UNITED STATES PATENT AND TRADEMARK OFFICE

APPLICATION NO.	FILING DATE	FIRST NAMED INVENTOR	ATTORNEY DOCKET NO.	CONFIRMATION NO.
10/593,978	09/22/2006	Hayato Yoshino	1018773-000046	3260
21839 7590 01/10/2008 BUCHANAN, INGERSOLL & ROONEY PC POST OFFICE BOX 1404 ALEXANDRIA, VA 22313-1404			EXAMINER DESAI, NAISHADH N	
			ART UNIT 2834	PAPER NUMBER
			NOTIFICATION DATE 01/10/2008	DELIVERY MODE ELECTRONIC

Office Action Summary

DETAILED ACTION

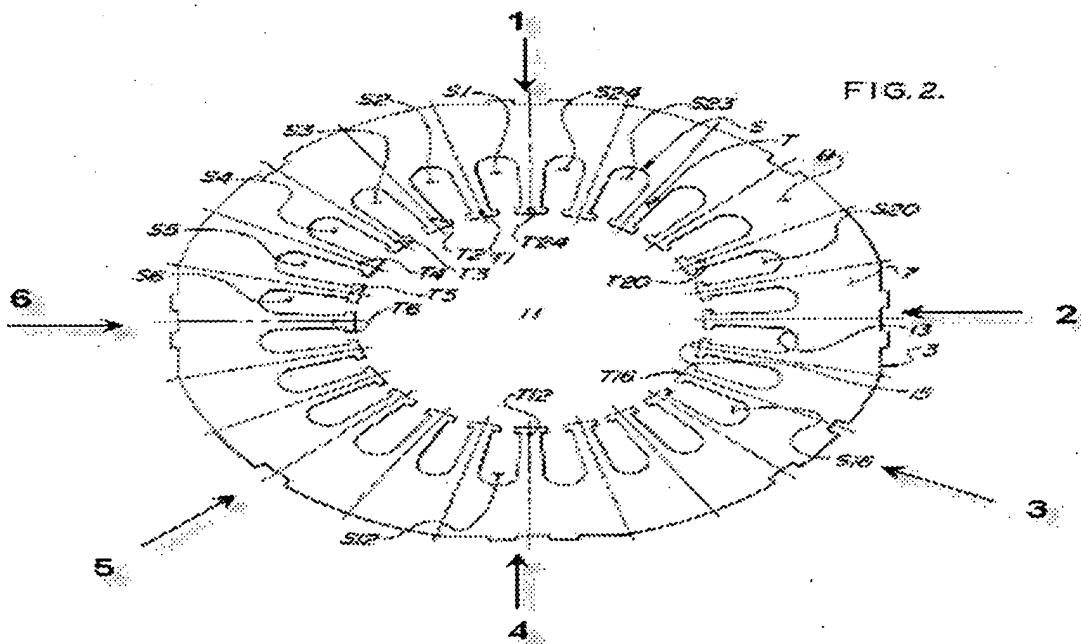
A single-phase motor having (abstract):

a stator including a stator iron core formed by laminating a plurality of electromagnetic steel sheets (Col 3 ll 46-50) and provided with a slot and single-phase two-pole distributed windings composed of a main winding and an auxiliary winding contained in the slot (abstract and Col 3 ll 57-65); and

a rotor placed through a gap on an inner circumference of the stator (Col 3 ll 46-57), the single-phase motor comprising at least five notches each having a roughly straight lined shape on an outer circumference of the stator iron core (Fig 2), so that a quadrangle is formed by straight lines including four notches out of the at least five notches (Fig 2 shows that a quadrangle can be drawn if straight lines are drawn from the notches).

The single-phase motor of claim 1, wherein the single-phase motor comprises six notches, so that a rectangle or a square is formed by straight lines including four notches out of the six notches (Fig 2, 1-6 below shows that several straight lines can be drawn on an outer circumference of the stator to form a rectangle or square out of 4 lines).

a stator including a stator iron core formed by laminating a plurality of electromagnetic steel sheets and provided with a slot between stator teeth ((Col 3 ll 46-50 and Fig 2 above), and single-phase two-pole distributed windings composed of a main winding and an auxiliary winding contained in the slot (abstract and Col 3 ll 57-65); and a rotor placed through a gap on an inner circumference of the stator (Col 3 ll 46-57), the single-phase motor comprising a notch having an approximately same width as the stator teeth on an outer circumference of the stator iron core (Fig 2,5 above).
